CHANGES & MODIFICATIONS:

BY: Richard J. [Signature]
DATE: 07/27/22
REVISION: 03/15/23
SCALE: 1"=1'
MODEL: P50

1782

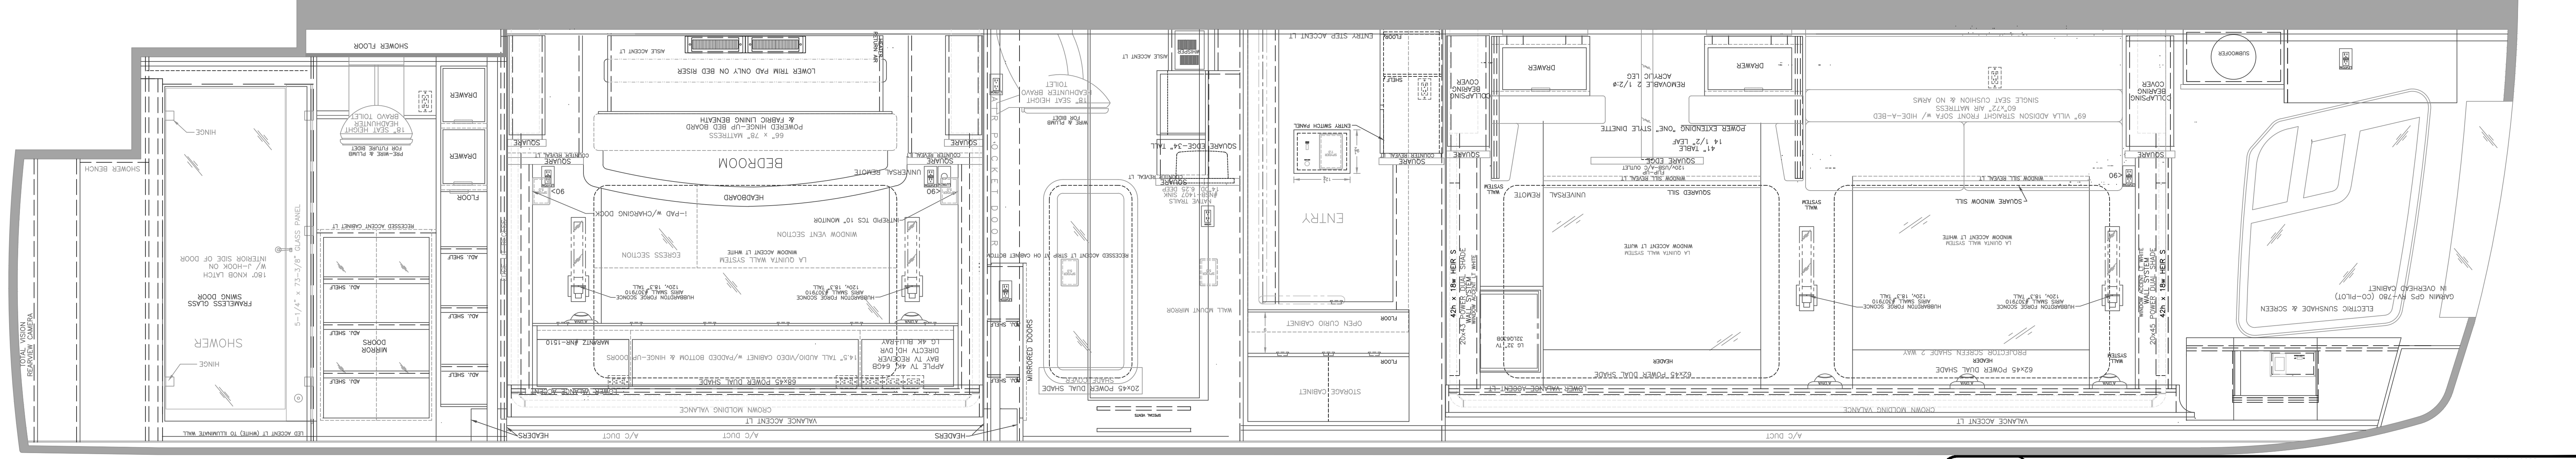
Item #	Ref #	Description
1	1	AV cabinet to be above head of bed in #3 room, with the cabinet built at 14.5" tall to duplicate a projector cabinet for future use.
2	1	Rear bath vanity cabinet to have all drawers in line of doors below sink. Reference coach 1749 for bathroom layout. At center drawer stack, add 2 120V A/C outlets at back of middle drawer for hair tool storage and use.
3	1	Add broom closet between refrigerator and washer/dryer. Closet to have 1 full height door with open space for broom/mop storage. Add roof above, exact height TBD. Door to have trim that matches refrigerator. Add 120V A/C outlets inside lower section at back wall.
4	1	At rear bath upper cabinet above vanity add wall mount faucets. Delete puck lights, and move outlets inside the upper cabinet. Add single grab bar on outside of cabinet directly in front of the bathroom. Cabinet to be built deeper and/or sink need adjust closer to sink wall to allow for faucets to land at center of sink. See Details for details.

5	1	Add overhead cabinet in #1 slide over restrooms for projector and storage.
6	1	#2 cabinet to be built out as follows: had closet to have upper storage, with lower section pull out clothes hamper. All closet to be upper and lower doors with full hanging space. Lower #2 section to be a large equal size drawers.
7	1	Add 3 towel bars above rear bath above commode, with upper closet above with mirror doors.
8	1	Add cabinet behind restrooms #2 room and above #1 rest. Cabinet to have full section upper storage with taller top, and folded dividers with view on end to wedge between restrooms. All sections to be 2" deep. Add 2 120V A/C outlets stacked on top of each other between restrooms.
9	1	Add edge of panels at left bedroom walls, Qty. 2 total.
10	1	Rear bath head closet to have 2 drawers below, with 1 adjustable shelves behind a door on top.
11	1	Co-Pilot seat to be Queen size.
12	1	Delete upper cabinet above vanity in half bath. Add hanging mirror on half bath wall.

13	1	Highstands next to bed to have lower highstands only with drawers.
14	200.0	Delete window in mid entry door.
15	301.1	Add electric latches to refrigerator door and drawers.
16	301.1	Cover lower refrigerator panel in laminate to match refrigerator. Reference coach 1753.
17	301.1	Refrigerator to be pushed back against sink wall. Pocket behind door closed to be used for wires, vent, and refrigerator footings/anchors.
18	314.2	Special microwave - GE Cafe Series, matte black, CVM15793D1. Handle to be brushed black.
19	317.0/318.0	Install Hinged fridge bath cooler in lower front bay facing left in lieu of chest freezer.
20	400.0	Add cabinet above entry door to be storage with adjustable shelves/wall with 1" open glass space below for pictures in lieu of glass cabinet. Reference coach 1759.
21	400.0	Premium tie at entry side walls.
22	400.0	Premium tie at rear side walls.
23	401.1/401.2	Head pocket door to be framed with metal insert. Left side to clear mirror. All pocket door to have head and left side clear mirror.

24	402.0	Premium laminate a cabinet of coach. See Interior sheet.
25	402.0	Premium quartz material at galley backsplash. Premium tie at rear bath and half bath backsplash, and half bath leather top.
26	403.0	Premium Ultra leather to be used at cab seating, sofa, dinette, restrooms, vanity, see interior sheet for details.
27	403.0	Premium wall materials at wallpaper, and wall systems.
28	403.0	Add recessed lighting to bedroom in addition to same. Bedroom Qty. 3, cabin Qty. 4.
29	403.0	Rearward two storage bays to feature powered trays, bay of entry door to be manual. Forward storage bay to have one very bay for grill cabinet.
30	403.0	Add illumination tray controls at bay doors on both bath and aft storage bays at both point and in-line side of coach.
31	403.0	Add additional light strip behind vanity, reference coach 1742.
32	400.0	Add recessed lighting to all window sills.
33	400.0	Add recessed light strip on back of upper galley, back of rear bath vanity cabinet, cabinet above commode in both rear and half bath. Remove puck lights under each cabinet except the galley.

34	400.0	Counter recessed lighting to be at galley, entry cabinet, half bath, restrooms, #3 bath, and rear bath.
35	400.0	Toe kick accent lighting at galley, half bath, bed room trim pad, and rear bath.
36	400.0	Add rear bath saddle, make top taller to meet bottom from falling out.
37	400.0	Add matte black robe hooks to shower glass feet of door. Shower glass hardware to be matte black.
38	400.0	Add custom speakers to front dash area like coach 1785.
39	400.0	Remove sound ceiling speakers per Anthony Galles A/Dina SE in lieu of standard. Color match to ceiling.
40	400.0	Add a projection TV system as an entertainment. To be Custom UHDTV in addition to standard LED TV overhead. Requires custom production system in place of standard window sunscreen cassette of projector. Add 3 bluetooth speakers and bluetooth transmitter to allow for outside viewing of projector. Surround sound system to be arranged around projection. Bluelay player to be included. Add note for details.

41	400.0	Add 55" OLED TV with cabinet in #2 bedroom to be deeper to accommodate storage behind TV. TV to be open with powered arm similar to 1717.
42	400.0	Add recessed lighting to bedroom in addition to same. Bedroom Qty. 3, cabin Qty. 4.
43	400.0	Add AppleTV at salon, bedroom, and belly TV Qty. 3.
44	400.0	Add iPad to aft side of bed.
45	400.0	Add Curt Spectrum Trailer Brake Controller 53120.
46	400.0	Add rear locker covers that is covered in material to be mounted next to safe sides. See Note for details.
47	400.0	Osman to be David style.
48	400.0	Add 120V A/C outlet at head of #4, outlet to be directly above bearing top.
49	400.0	Delete window awnings per wire for future use.
50	400.0	Add additional clearances to allow for plumbing area and the face of the sidemaster seats.
51	400.0	Add additional clearance lights to duplicate 1738 layout. 5 additional across the top, and 4 additional across the lower section on the same panel.

52	400.0	All equipment with ethernet capability to be hardwired to coach IP network, with extra cat 6 cable to every possible location.
53	400.0	All available marker and clearance lights to be clear lens.
54	400.0	Add 3 camera monitor screens above driver, seat in lieu of the 1 standard.
55	400.0	17Vageer CVM1555 camera roof mounted for viewing low limits and obstructions. Mount one at center of coach facing forward, and one at left and right aft. All will be trailer camera heads in lieu of a new monitor. Reference government of 1722 coach.
56	400.0	Delete cab drapes, add cover for driver's seatbelt.
57	400.0	Add 120V A/C outlet inside cabinet above toilet in half bath.
